## Service Bulletin

**SB 21-2**  
**3-19-81**

SUBJECT: CLUTCH RELEASE SYSTEM  
 VEHICLES: 308 MODELS  
 SERIAL NO: MODEL FROM SERIAL NO.  
 308 GTB 32829  
 308 GTS 32733  
 308 GTBi/GTSi 32667

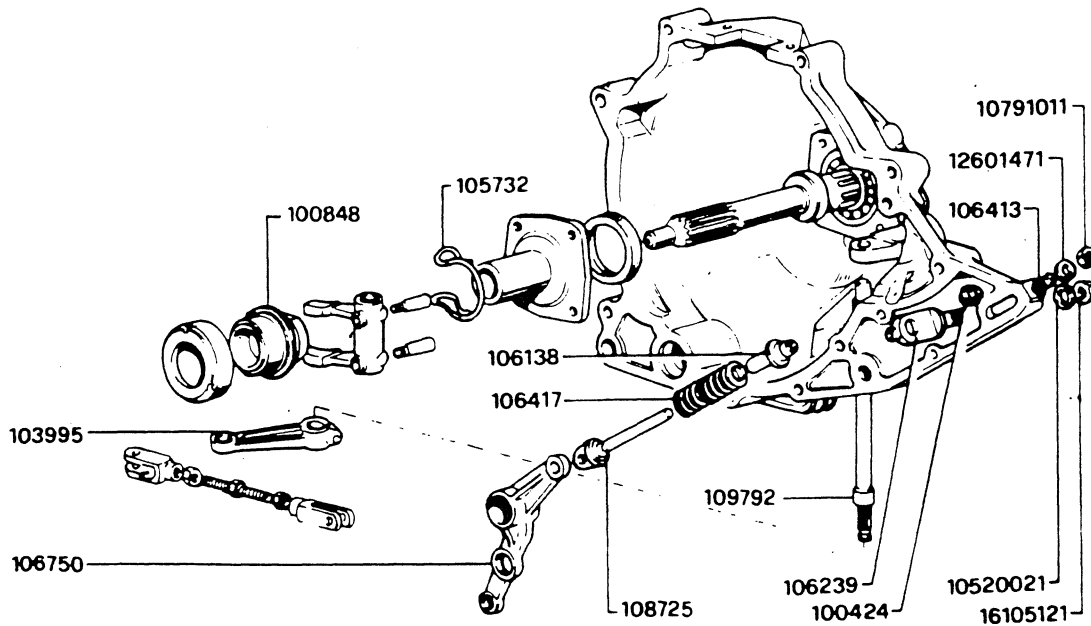
The before modification clutch release control system can be changed to the new "self adjusting" system by:

- Replacing the old clutch pedal with the modified pedal, Part No. 116324, removing the pedal rest adjuster and its locknut, and connecting the return spring.
- Removing all existing components illustrated in above drawing and installing new components, Part No. 116327, 116472, and 116326.

NOTE: All existing before modification components not identified by a part number on above drawing can be used to retrofit system.

Description	Part No.
Clutch Housing*	116801
Clutch Control Lever	116472
Clutch Control Lever and Shaft Unit	116327
Clutch Pedal	116324
Release Bearing Sleeve	116326

\* The before modification clutch housing, Part No. 109118 can be used if the overcenter spring, Part No. 106417, and its related components, are removed. Please refer to next illustration.

AFTER MODIFICATION

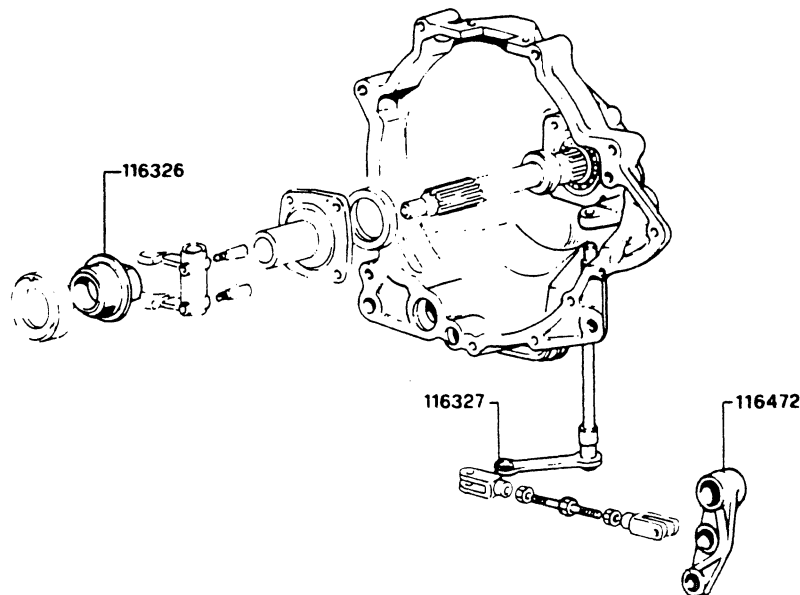
- Adjust control rod (6) to a length of 105mm (4-1/8")
- Check that center of lower ball joint of lever (2) is 40 to 45mm (1-5/8" to 1-3/4") behind the vertical line passing through bolt (8).  
If necessary adjust control rod (6) to obtain this dimension.
- By adjusting coupling sleeve (7) move clutch pedal in line with the brake pedal.

## BEFORE MODIFICATION

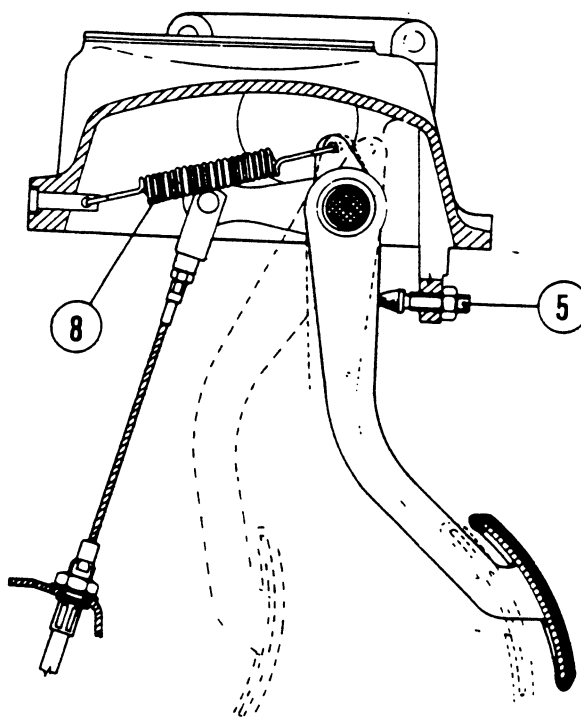
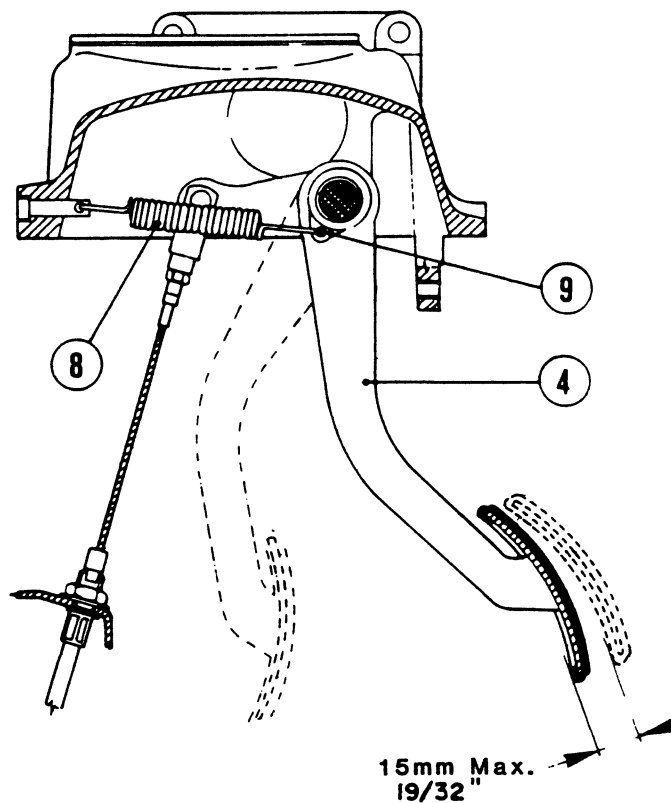
- Pedal rest adjuster (5)
- Pedal return spring (8)

- Pedal return spring (8) is hooked to lower bracket (9).
- Pedal Rest adjuster (5) has been removed.
- Pedal must be aligned as explained on page 4
- When the clutch disc is worn to the point where the clutch pedal is 15mm (19/32") beyond the brake pedal when both pedals are released, the clutch pedal must be realigned as explained on page 4
